EAGLE MOUNTAIN CITY
PLANNING COMMISSION MEETING AGENDA

TUESDAY, JULY 12TH, 2016 AT 6:00 P.M.

Planning Commission Staff Report

Project: Heatherwood Church
Applicant: The Church of Jesus Christ of Latter-Day Saints
Request: Conditional Use Permit, Site Plan
Type of Action: Action Item, CUP Approval, Site Plan Recommendation

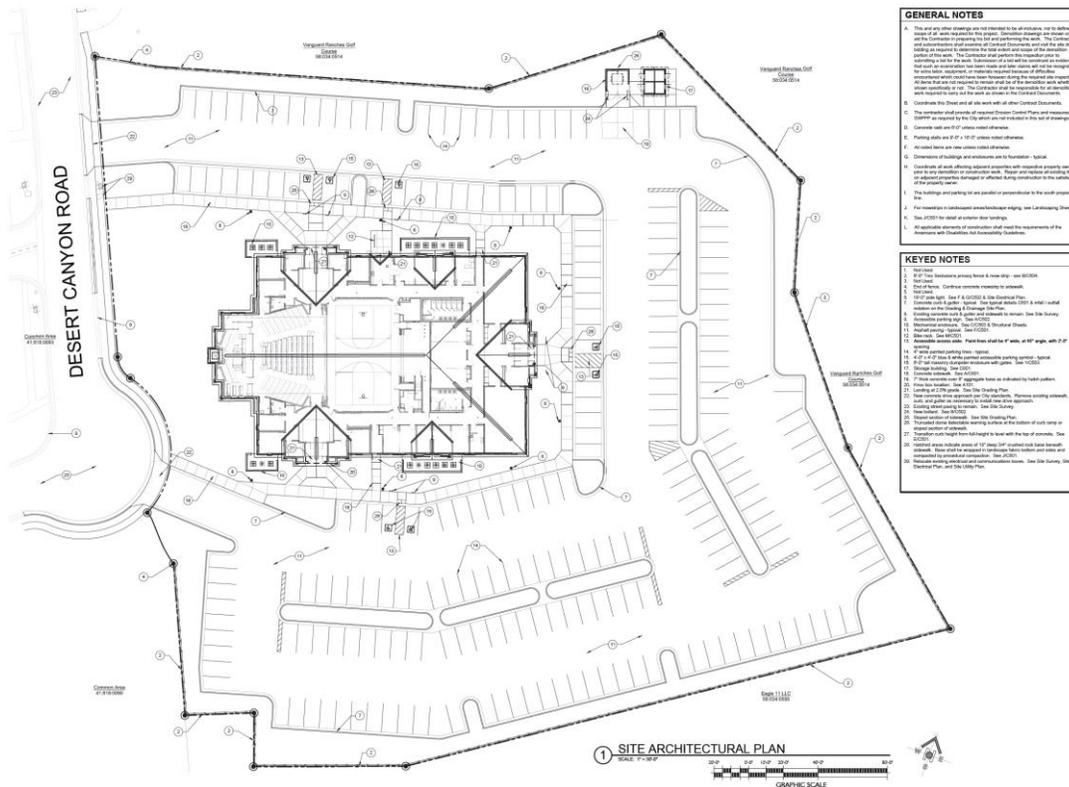
The applicant is proposing parking islands that do not have island bulb outs every 12 stalls (above). Rather the applicant is proposing islands between all rows of double parking, with no bulb outs. The applicant believes these parking islands without the bulb outs provide for better circulation, and make it easier to plow in the winter.

The Planning Commission has the authority to recommend either approval or denial of this parking layout to the City Council. There are several churches within the city that have parking layouts similar to the applicant's proposal including: the Silverlake LDS Church, The Porter's Crossing LDS Church.

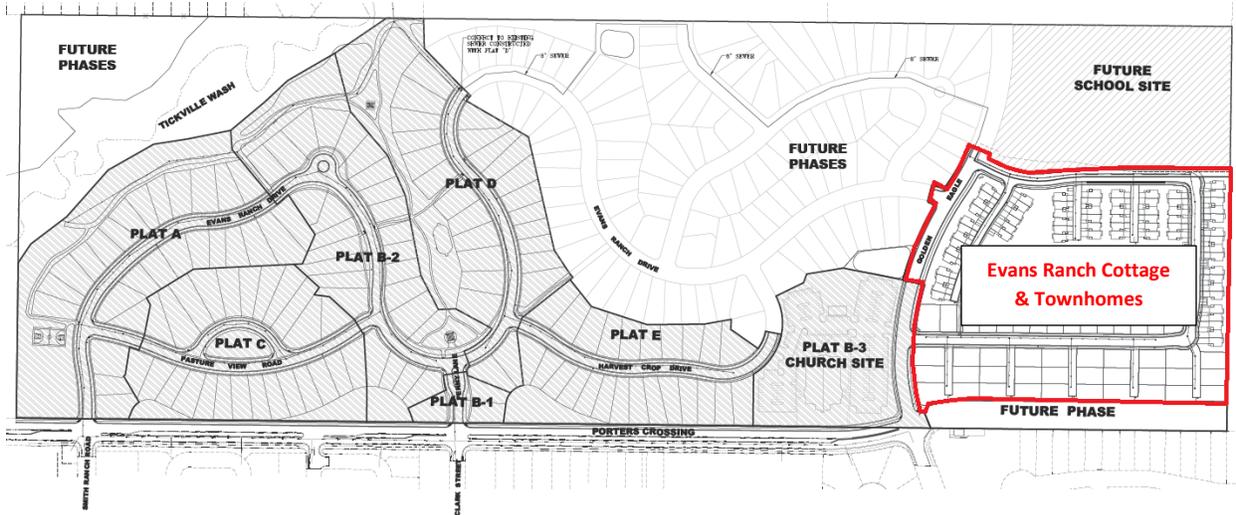
The Plat Calculations should show 9.76 acres in the Townhomes, rather than the 9.38 which are currently shown.

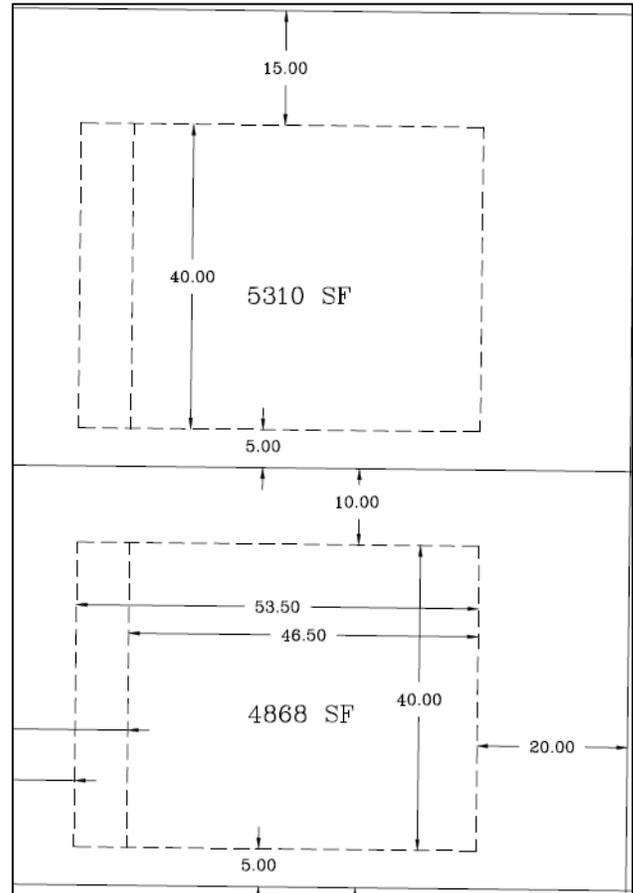
These setbacks should be shown on the plat.
